RENESAS TECHNICAL UPDATE

Product Category	LCD driver	Document No.	TN-PLC-A006A/E	Rev.	1.00
Title	Supplementary explanation on deep-standby_R61505U, R61505		Information Category	Technical Notification	
Applicable Product	R61505U, R61505	Lot No.	Reference Document		
		All

This letter provides supplementary explanation and instruction on deep-standby function.

Figure 1 Signal input timings when canceling deep-standby mode (16 bit interface mode)

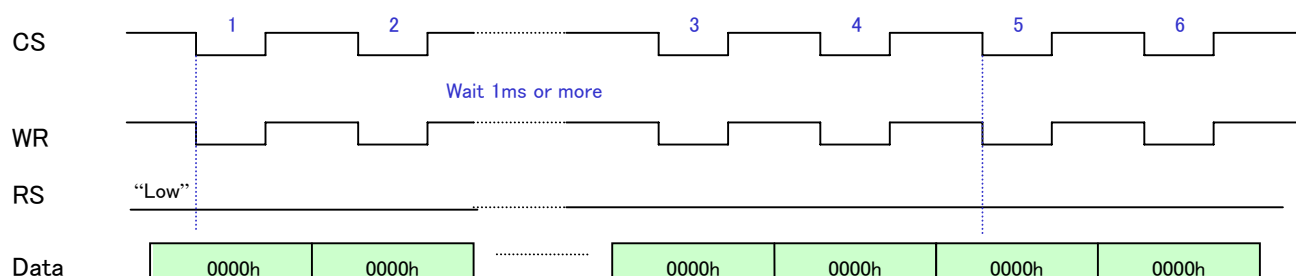
If your system design makes it difficult to input CS signal independently (for example, inputting WR signal synchronized with CS signal), please make sure to follow charts below in canceling deep-standby mode.

Instruction on deep-standby cancellation setting (When the system do not allow independent CS “Low” signal

Figure 3 Signal input timings when canceling deep-standby mode (8 bit interface mode) **Transfer synchronization**

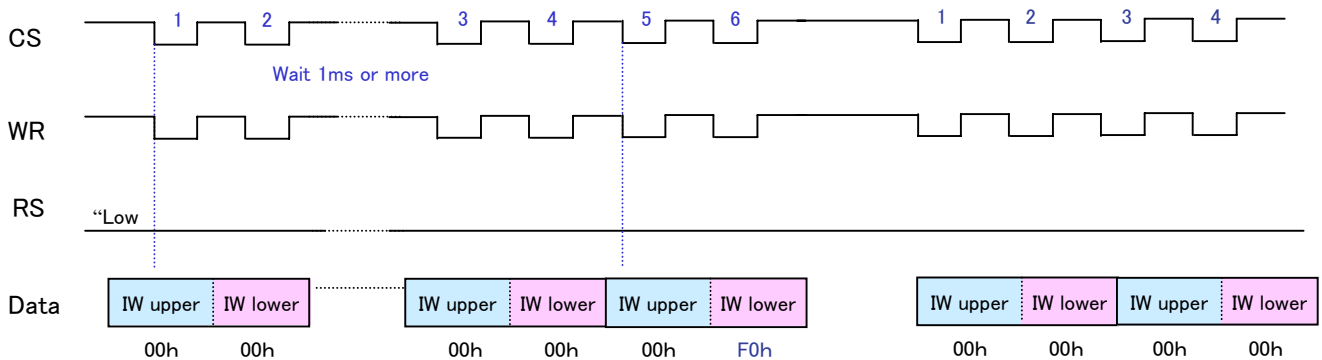
Cancel deep-standby mode by writing bus data "00h" five times and then writing bus data "F0h" once. Make sure to write in "00h" four times consecutively as the transfer synchronization process. Wait 1ms or more between 2nd and 3rd write-in operation.
